Mercedes-Benz

Campaign No. 2021050004, May, 2021

SUBJECT: **Model 907 Sprinter, Model Year 2019**
Update Incorrect VIN

D60.00-A054-06

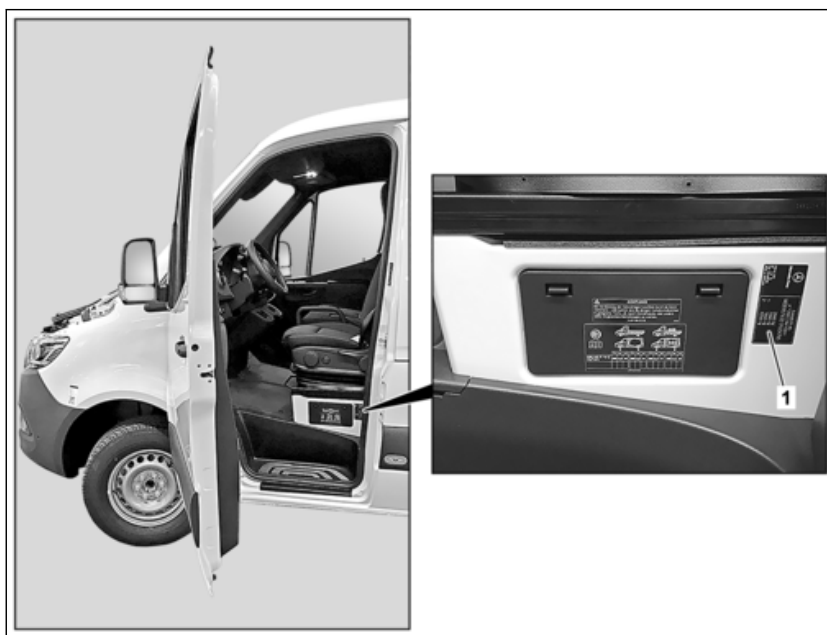
3	Replace information label (2).	 Bonding surface must be absolutely dry and free of dust and grease. This prevents any adhesion problems.  Incorrect vehicle identification number: WDZPF0ED6KT016360 Correct vehicle identification number: W1Z40FHYXKT016360  Aid of helper required. Cleaner	BR00.45-Z-1025-04A

D60.00-A055-79

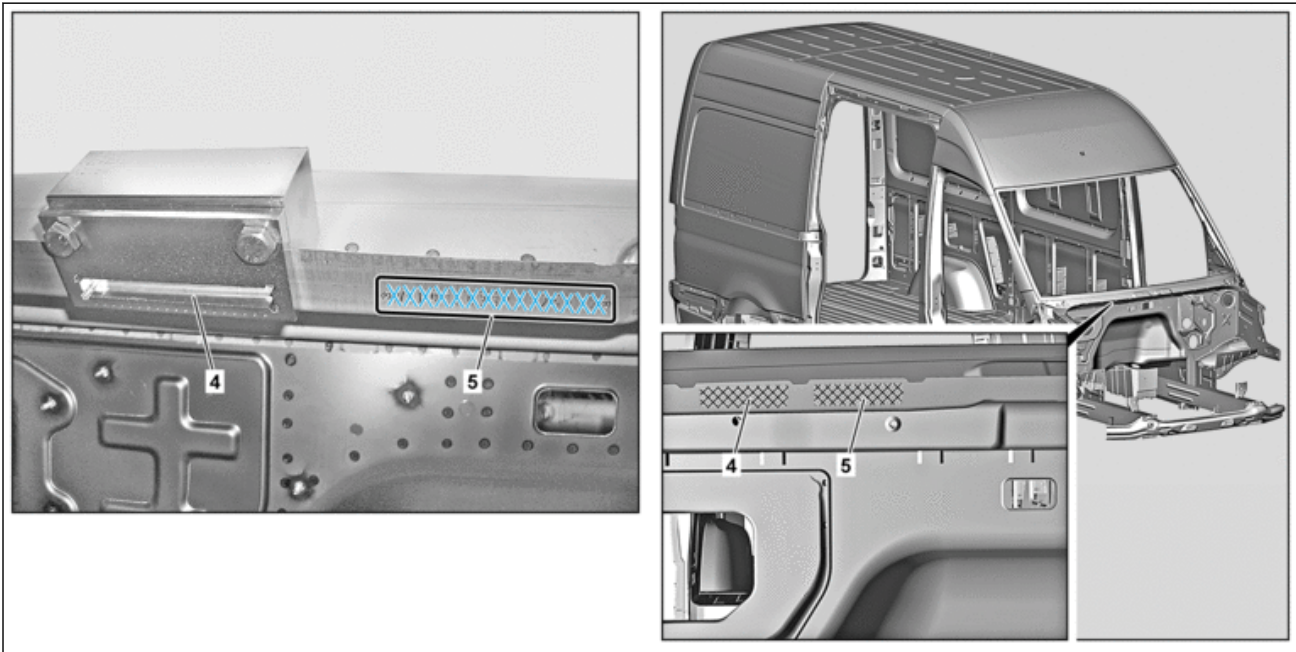
Remove		
4 	Remove ventilation box.		AR83.10-D-0010TS
5	Remove engine compartment seal in area of reserve field (4).		
	Punch in VIN		
6 	Stamp correct vehicle identification number into reserve field (4).	<p> Cross out incorrect vehicle identification number in standard field (5).</p> <p> Incorrect vehicle identification number: WDZPF0ED6KT016360</p> <p>Correct vehicle identification number: W1Z40FHYXKT016360</p> <p> Stamping guide</p> <p> Star marking punch</p> <p> Letter marking punch</p> <p> Letter marking punch</p> <p> Die stamp numbers</p>	<p>AR60.00-D-0800TS</p> <p>906 589 10 63 00</p> <p>000 589 02 39 00</p> <p>000 589 00 39 00</p> <p>000 589 03 39 00</p> <p>000 589 01 39 00</p>
 Danger	Risk of explosion caused by paint vapors igniting. Risk of poisoning caused by inhaling paint vapors.	No smoking! No open fire! Use respiratory protection, protective clothing, gloves, safety glasses and protective skin cream. Ensure that the area is well ventilated.	AS98.00-Z-0002-01A
